May 4, 2015

**NOTICE OF ADDENDUM
ADDENDUM 1
NAKOMA PARK PEDESTRIAN ENTRANCE STEPS-MASONRY REPAIRS
CONTRACT NO. 7392**

2
A1.2

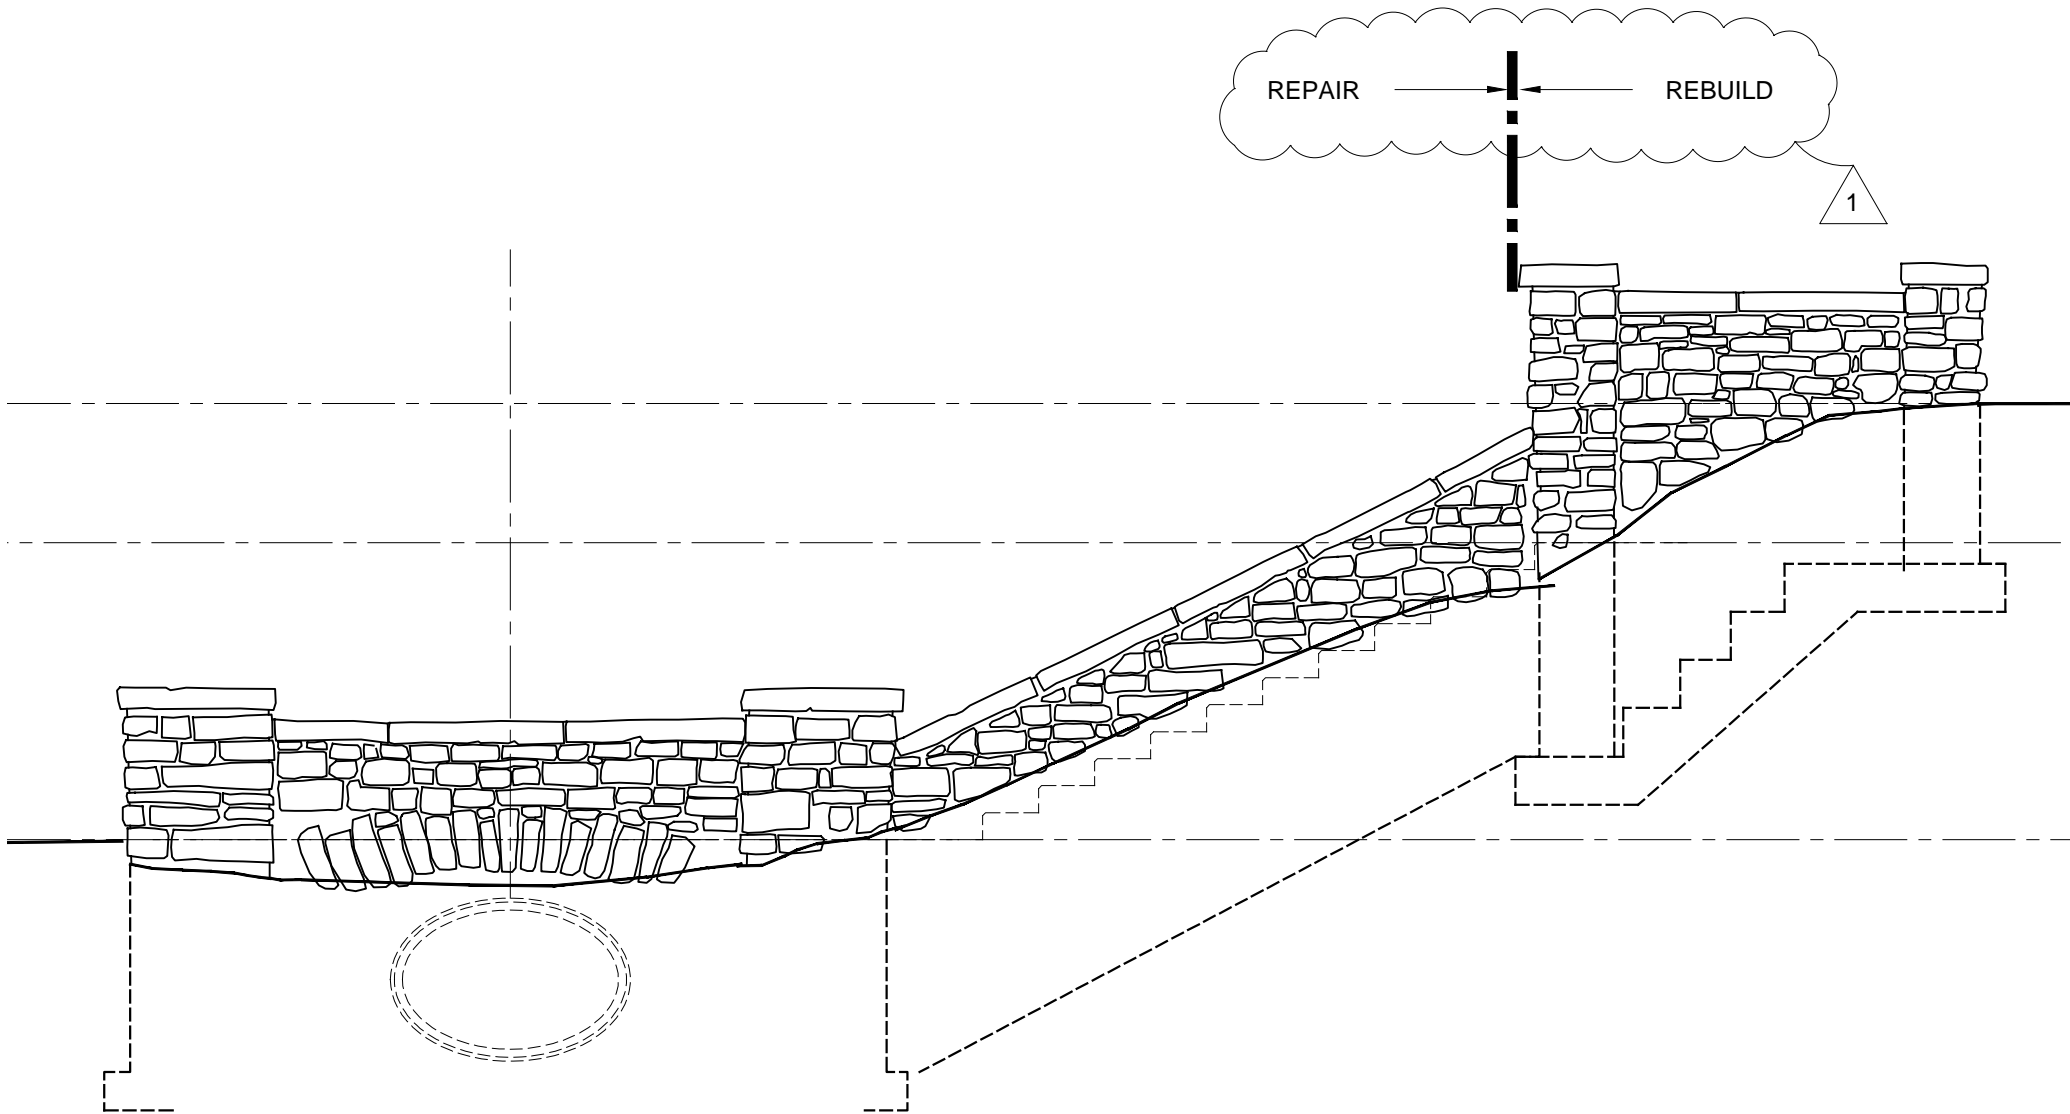
1. Revise 2/A1.2 per attached sketch.
2. Where drawings reference "Contract #7393", revise to read, "Contract #7392."

SOIL BORING LOCATION PLAN
Nakoma Park Stair Restoration
Madison, Wisconsin

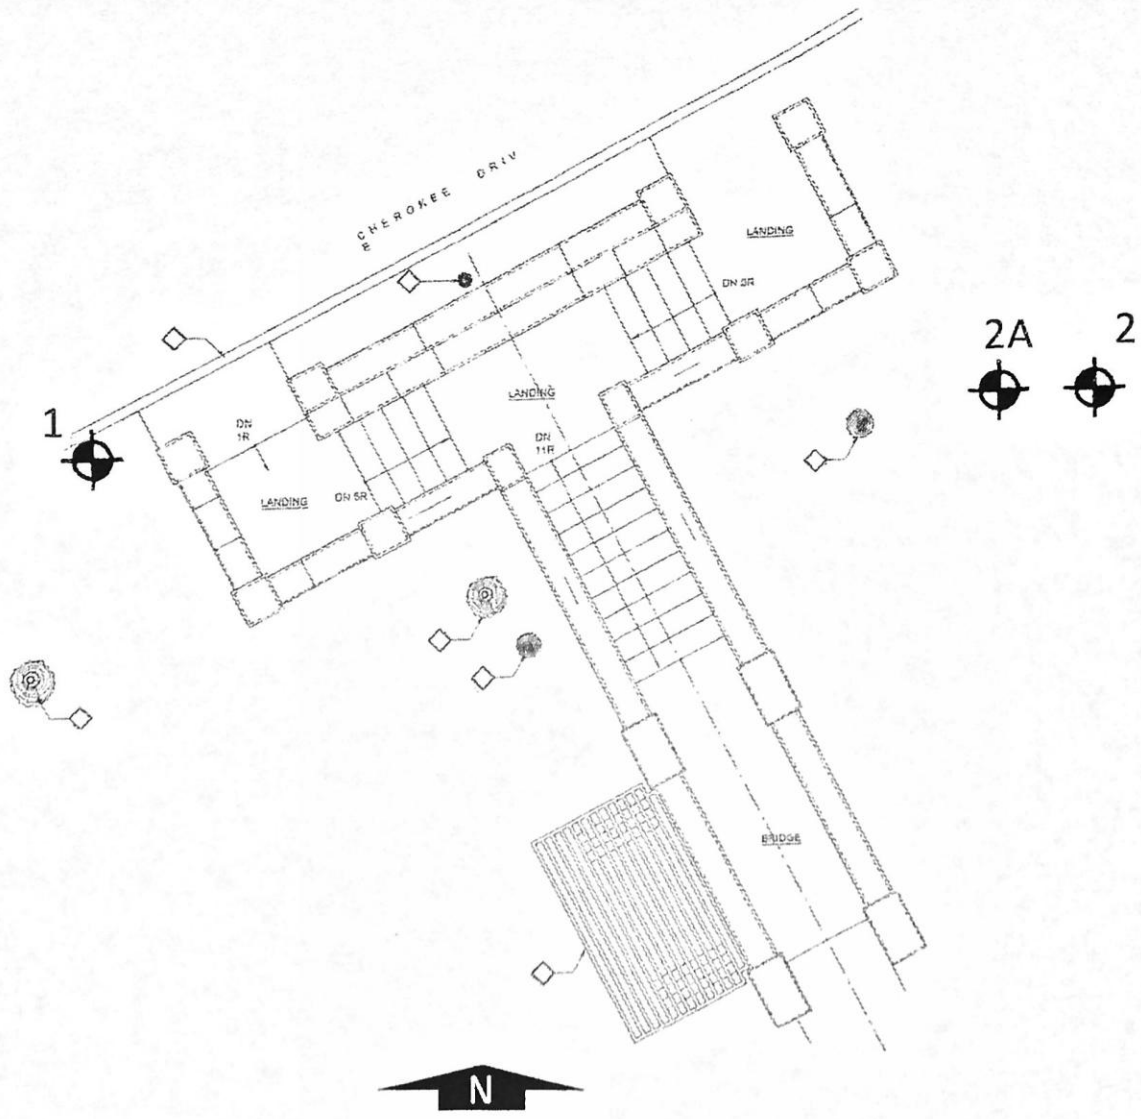
2. New (Replacement) stone shall be Wisconsin Dolomitic limestone, also referred to as Minnesota Dolomitic Limestone.
3. Soil borings are attached. See boring map and log of 3/1/15.
